# Justification for Class III Permit Modification April 2000 Solid Waste Management Unit 144 Operable Unit 1295 Round 7

(RCRA Permit No. NM5890110518)

**PROPOSAL FOR  
RISK-BASED NO FURTHER ACTION  
ENVIRONMENTAL RESTORATION SITE 144  
BUILDING 9980 SEPTIC SYSTEM  
OPERABLE UNIT 1295  
May 1997**

**FIGURE 1-2**  
Site Map for ER Site 144  
Sandia National Laboratories,  
New Mexico

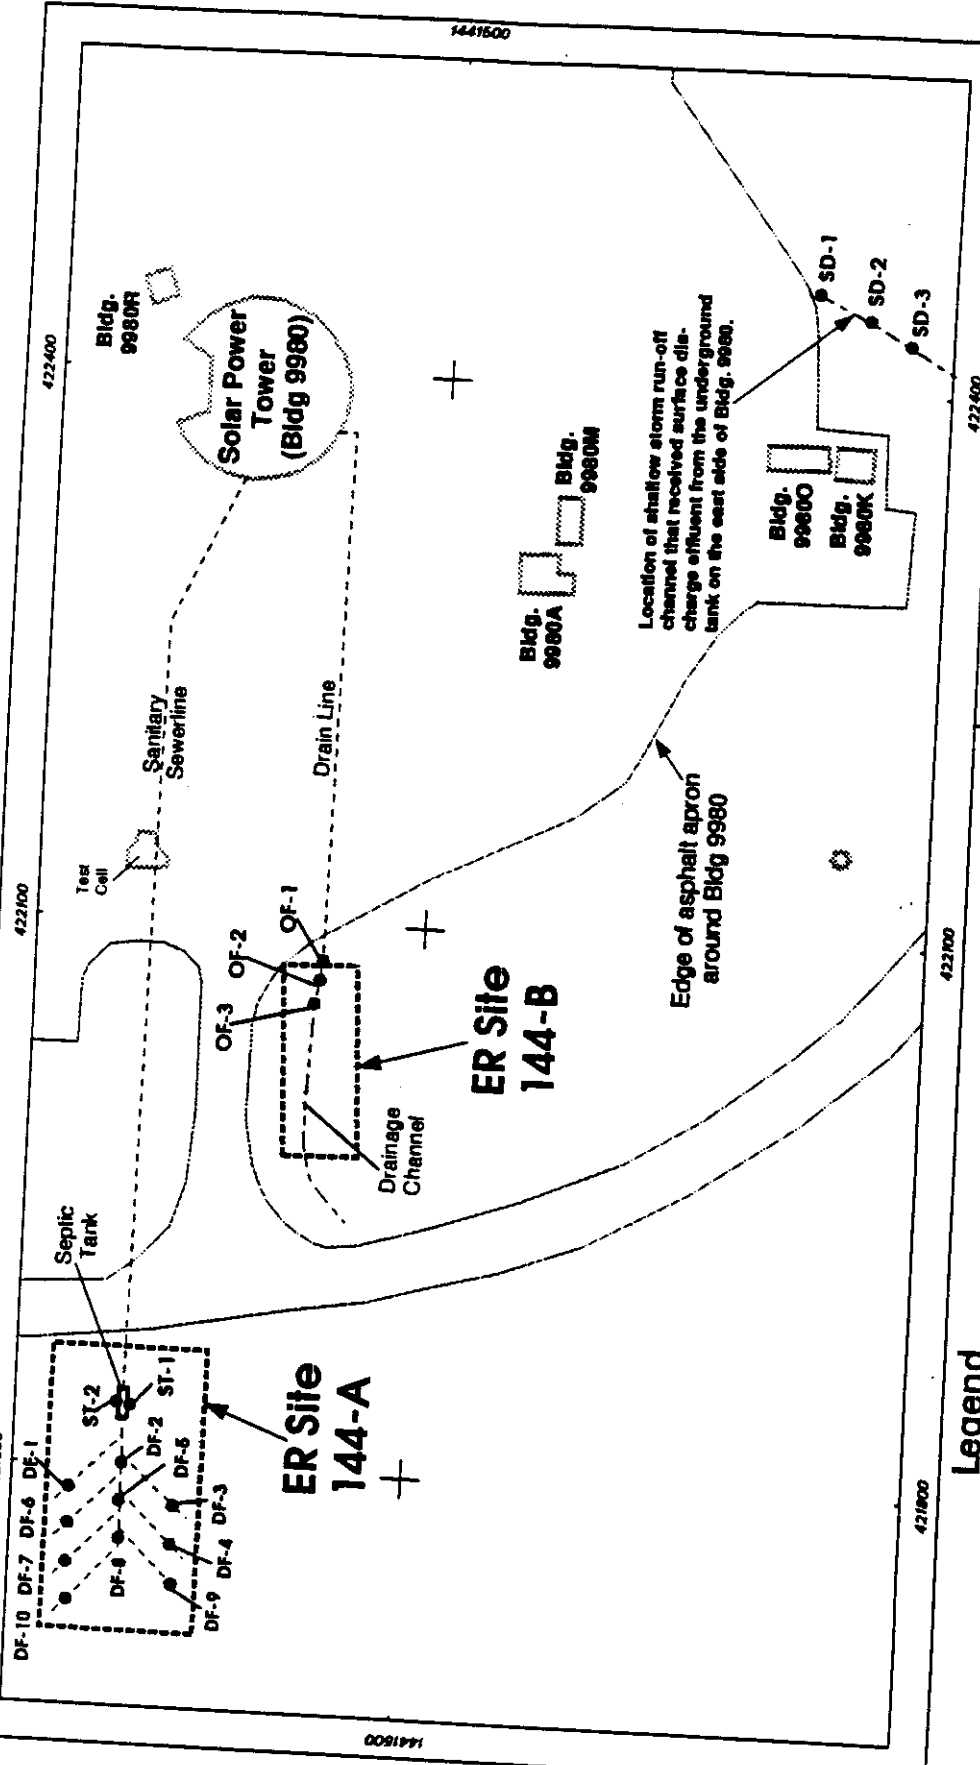
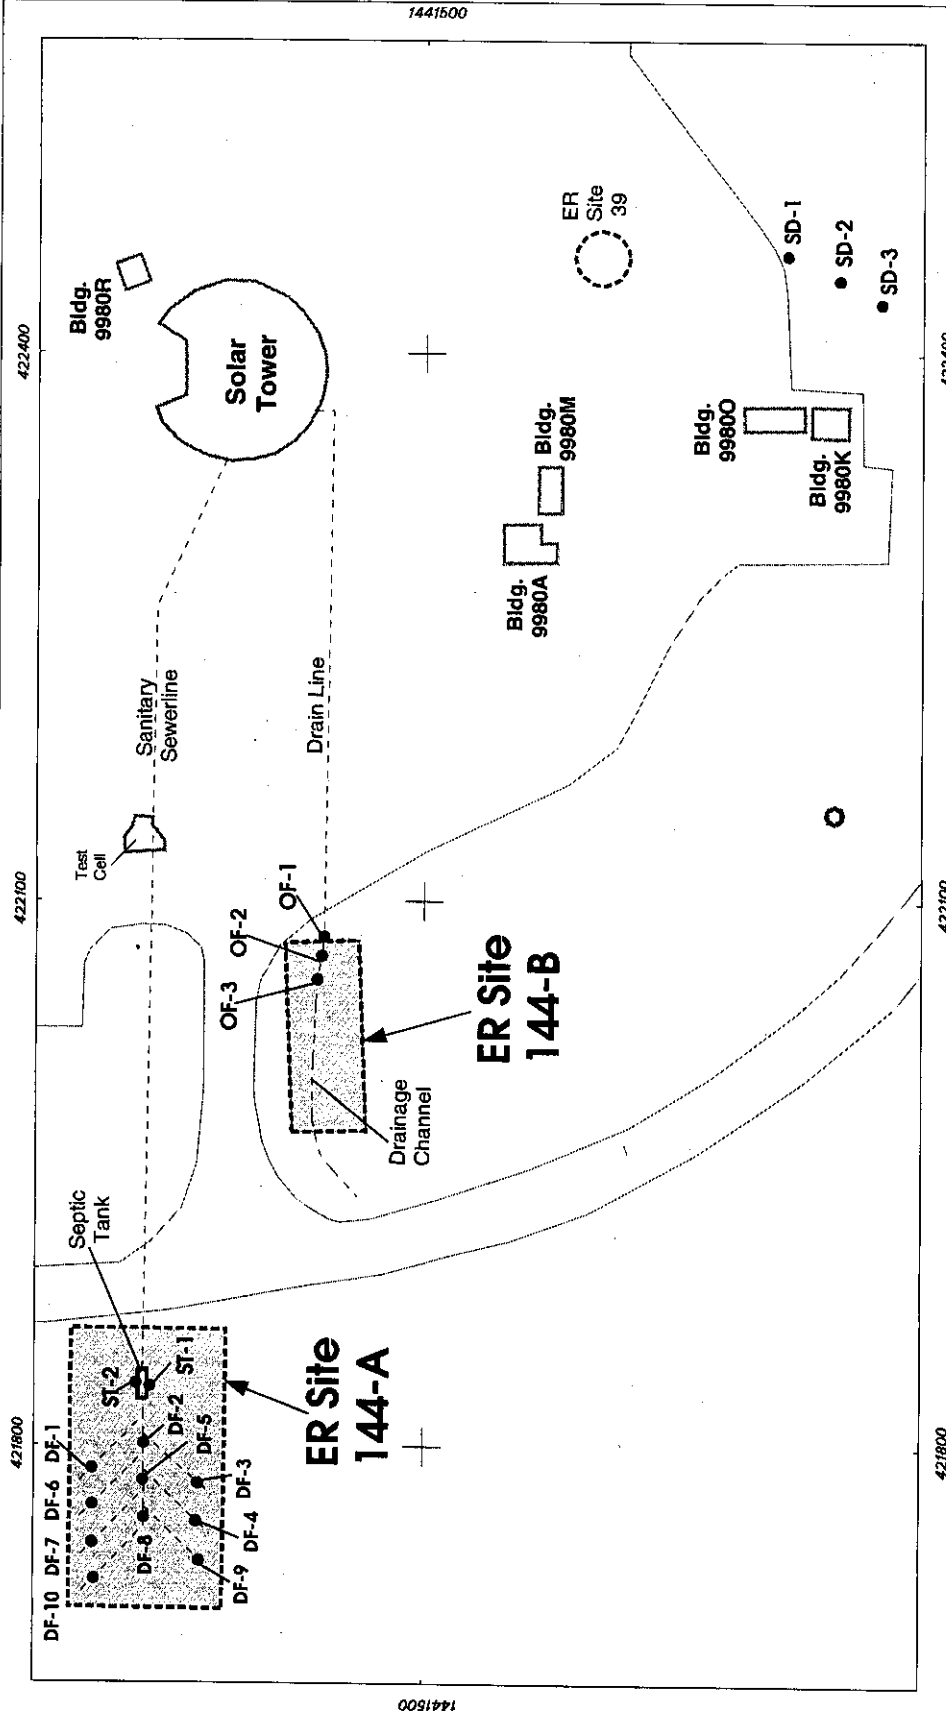
1. **Figure 1-2 is labeled "draft". See general comment 1.**

Response: A replacement Figure 1-2 without the word "draft" is provided in Attachment A.

**REVISED FIGURES 1-2 AND PETREX (APPENDIX A.3) SAMPLE LOCATIONS**

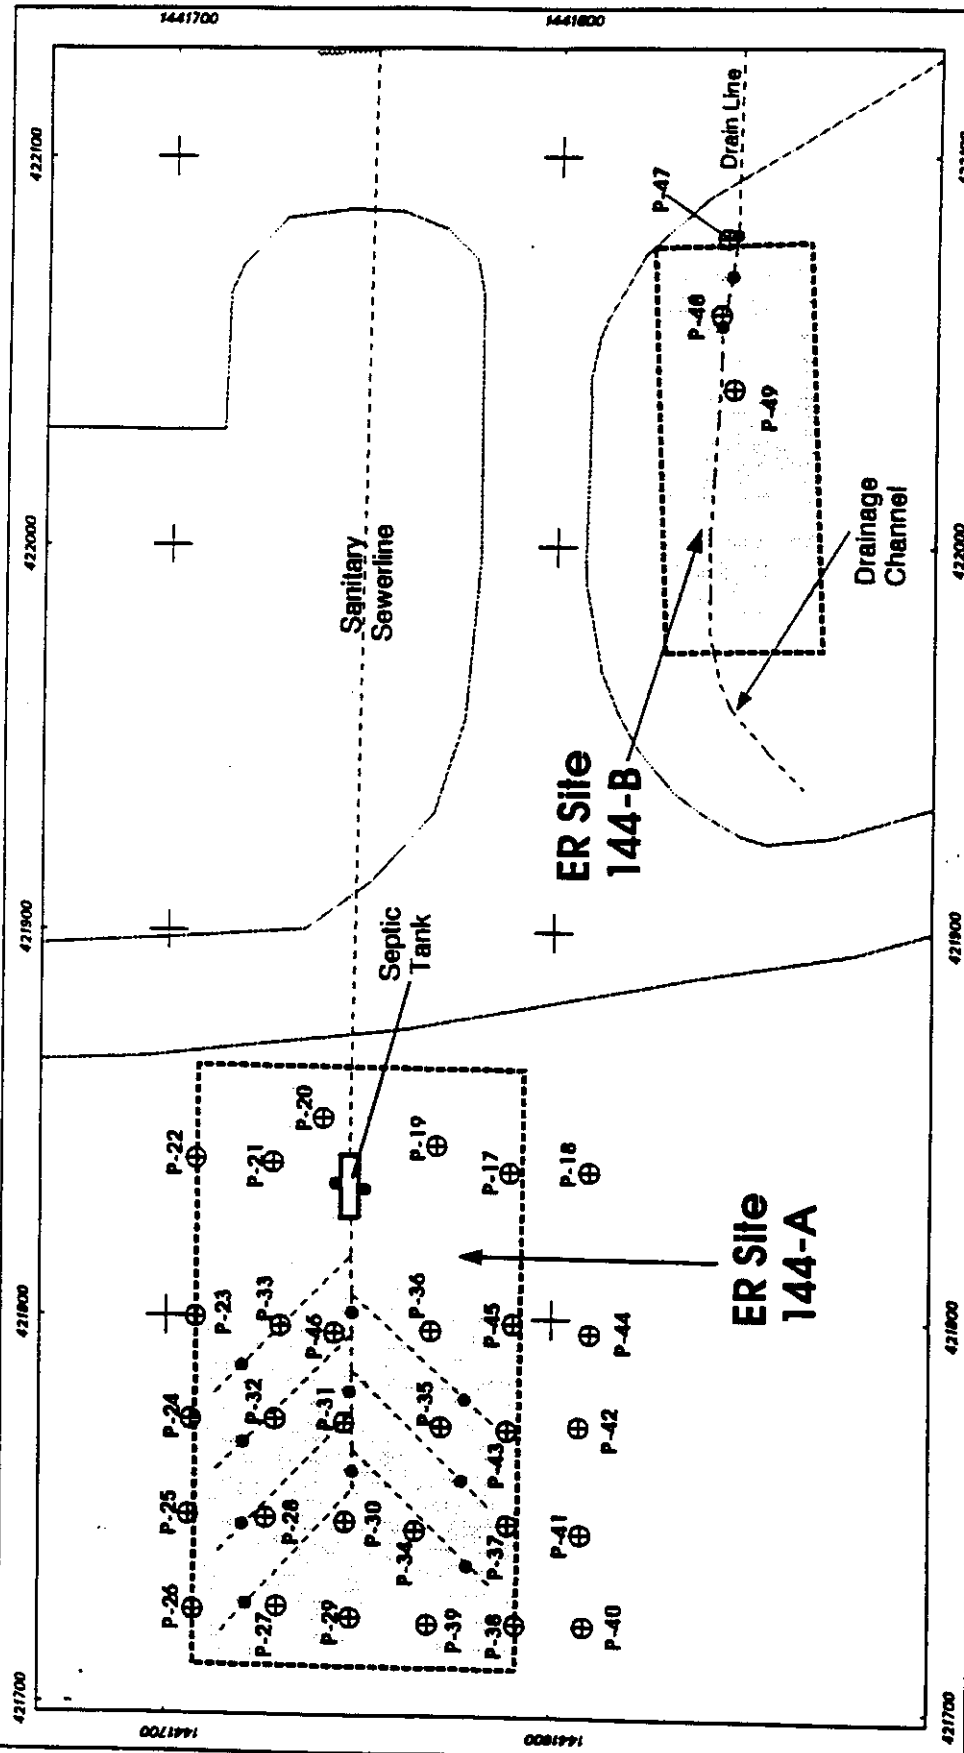
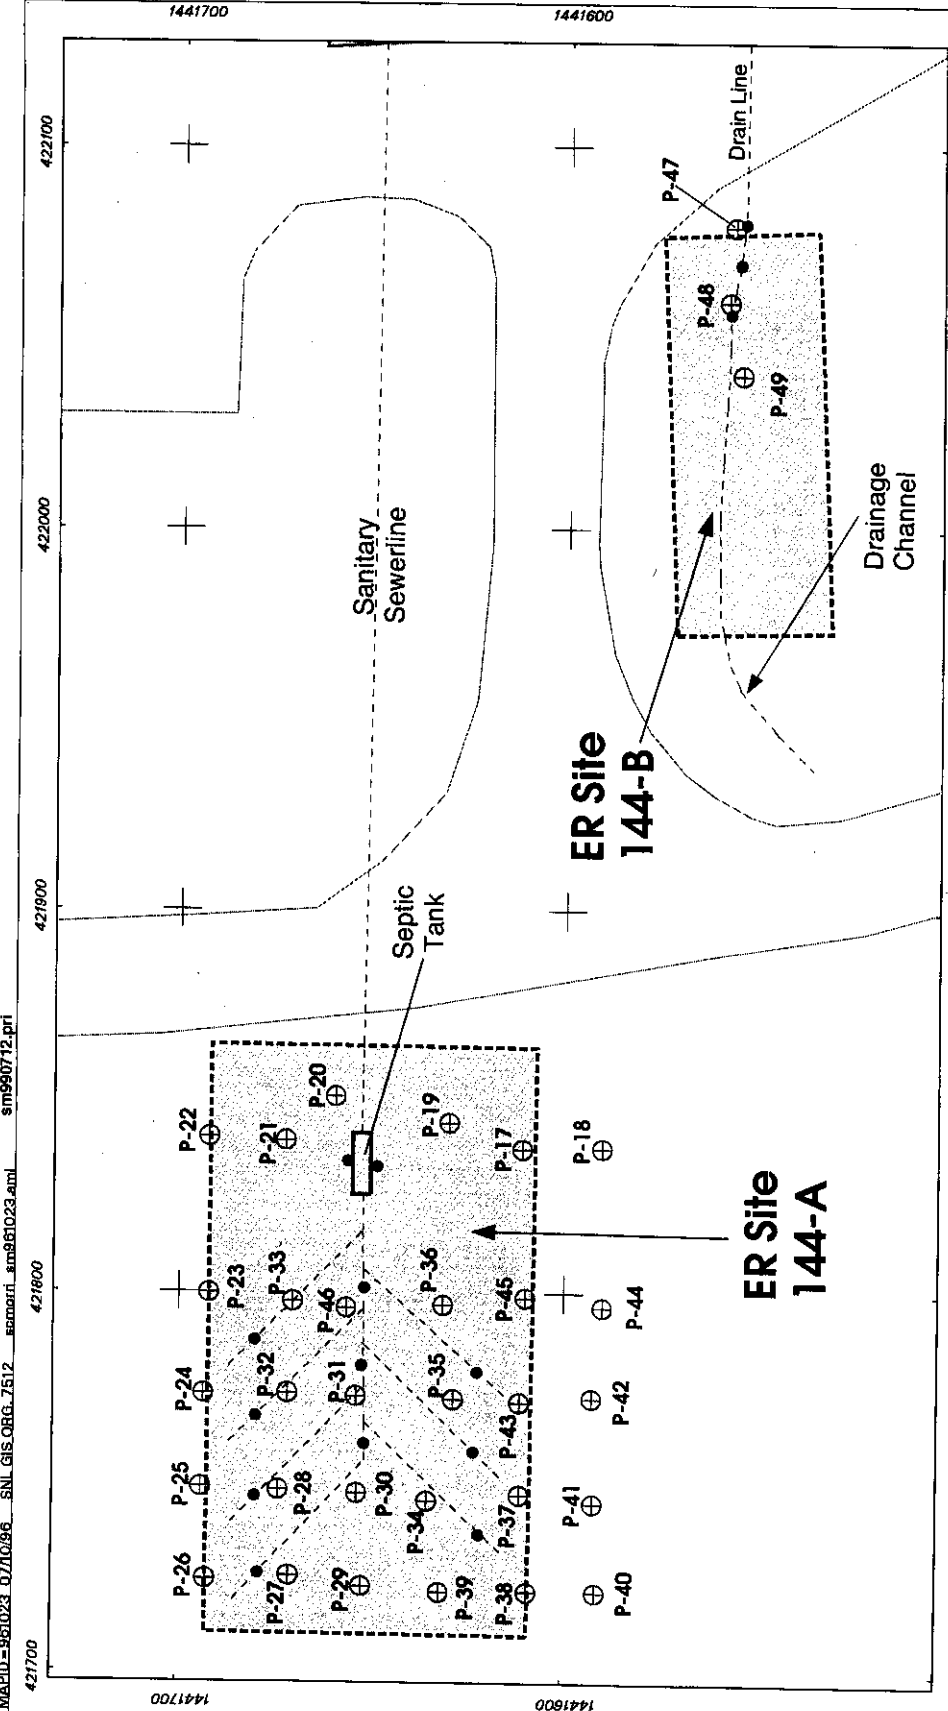
2. **Annex 6.3 – The map showing PETREX sampling locations (Appendix A.3) is labeled "draft". See general comment 1.**

Response: A replacement Annex 6.3 map that shows the ER Site 144 PETREX sampling locations, without the word "draft" is provided in Attachment A.
